Company	Trenz Electronic GmbH
PCN Number	PCN-20240302
Title	TE0725-03 to TE0725-04 Hardware Revision Change
Subject	Hardware Revision Change
Issue Date	2024-06-06

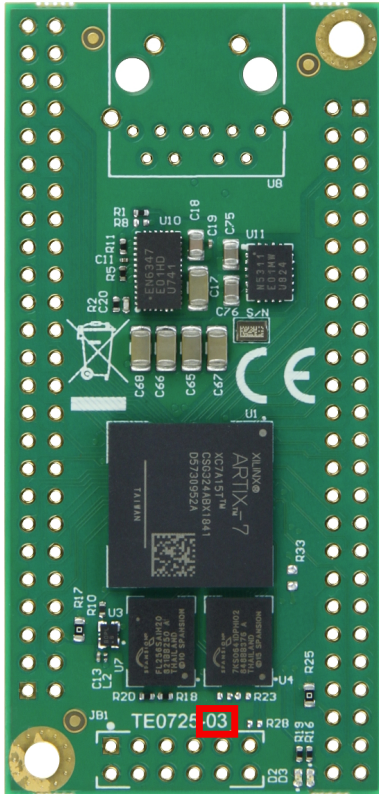
The revision number is shown on the top side of the PCB. Revision number position changes between REV03 and REV04 on top side of the PCB.
